RE: 780 Wallgrove Road, Horsley Park SSD-9601 Modification – Response to Submission - Transport Statement

Reference has been made to the Fairfield City Council's (Council) response sent on 02 May 2022 in relation to Modification (MOD 1) for SSD-9601 at 780 Wallgrove Road, Horsley Park (the Site). In this regard, Brickworks Land & Development (Brickworks) have commissioned Ason Group to prepare a response to the Council comments. Details of our assessment are as follows.

Swept path analysis of proposed hardstand area

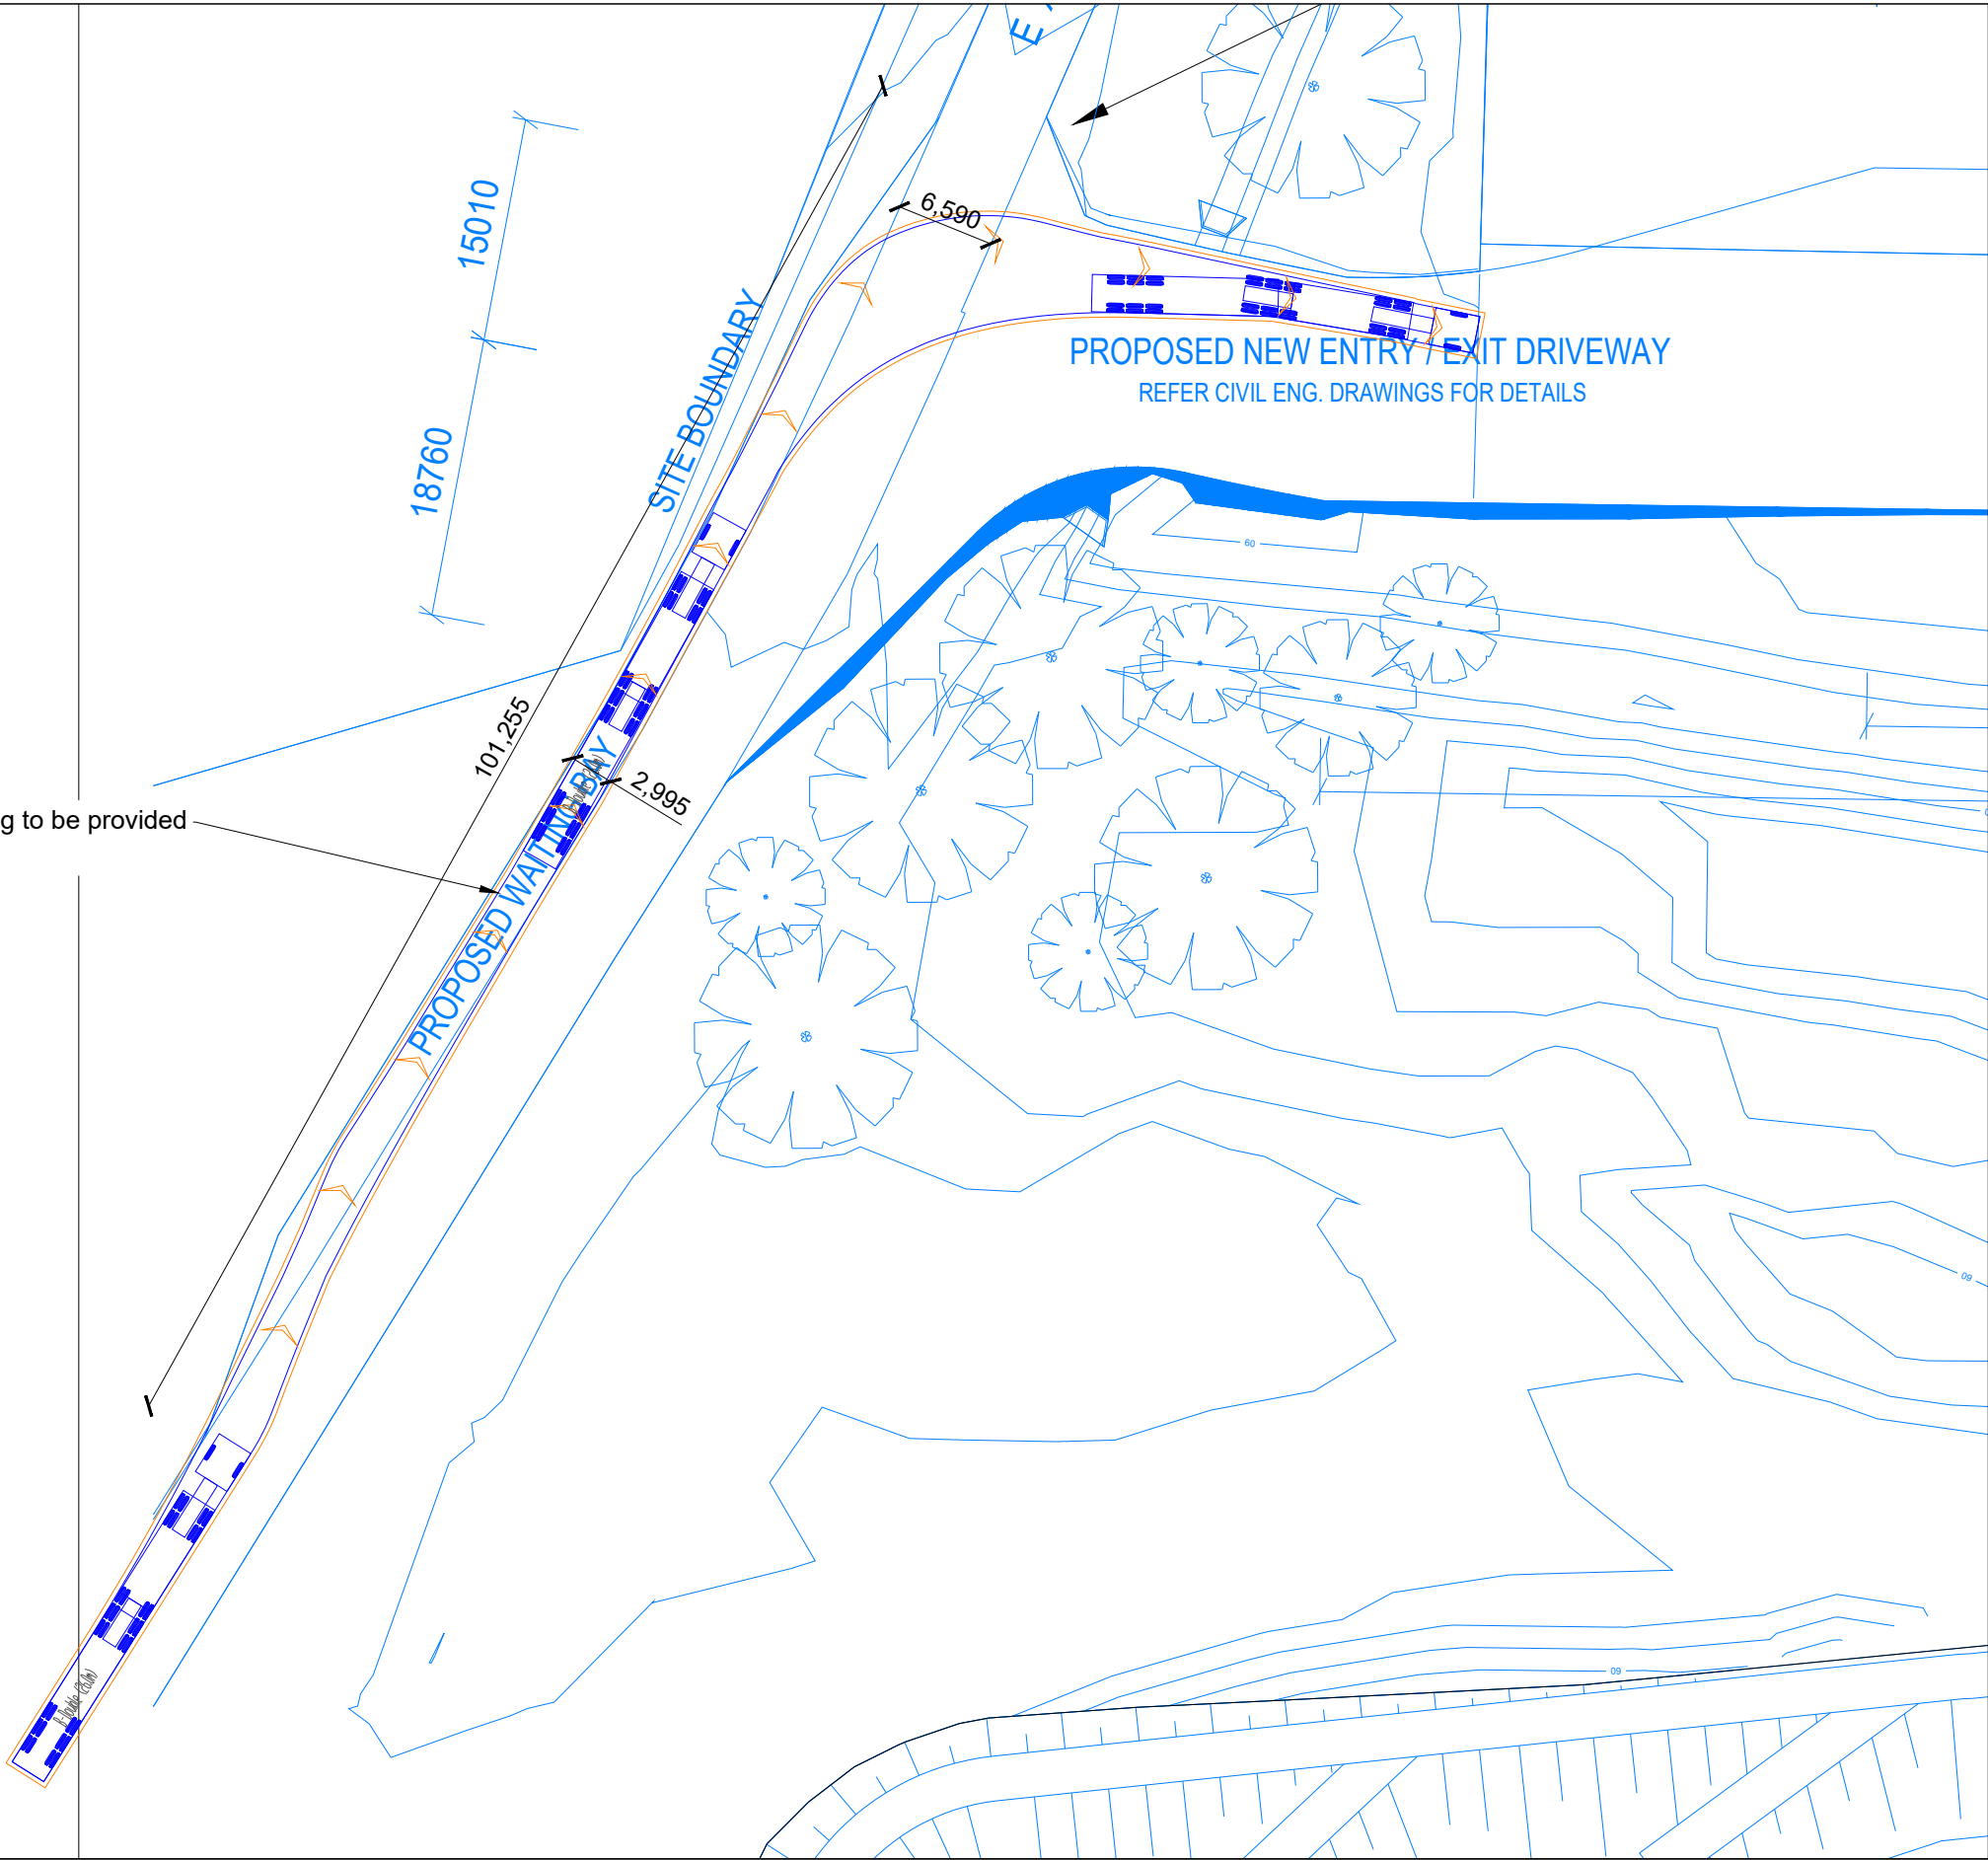
“The applicant shall provide swept path diagram(s) to demonstrate the intersection areas within the site have sufficient capacity to cater for two-way traffic movements;”

“With regard to heavy vehicles manoeuvring within the site, the applicant’s swept path diagrams shall demonstrate how heavy vehicles can satisfactorily manoeuvre into and out of the proposed new hardstand areas. This is to ensure that the design of the hardstand areas will be sufficient to accommodate the intended design vehicles. The plan shall be updated to show where one-way traffic flow is proposed within the site. Where two-way movements are permitted at the intersection areas, swept path analysis demonstrating that two-way simultaneous movements for the possible scenarios shall be shown.”

The projected heavy vehicle traffic generation is sufficiently low such that continuous two-way flow at the internal intersections is not warranted. The design generally provides for one-way circulation in accordance with best practise from a safety and efficiency standpoint. The proposed one-way circulation would result in fewer conflict points within the proposed hardstand area, facilitating safer use of the proposed hardstand area.

Appendix B provides swept path analysis demonstrating the one-way flow.

Please refer to Item 4 regarding two-way movements within the proposed hardstand area. Please refer to Appendix B for truck manoeuvres within the proposed hardstand.
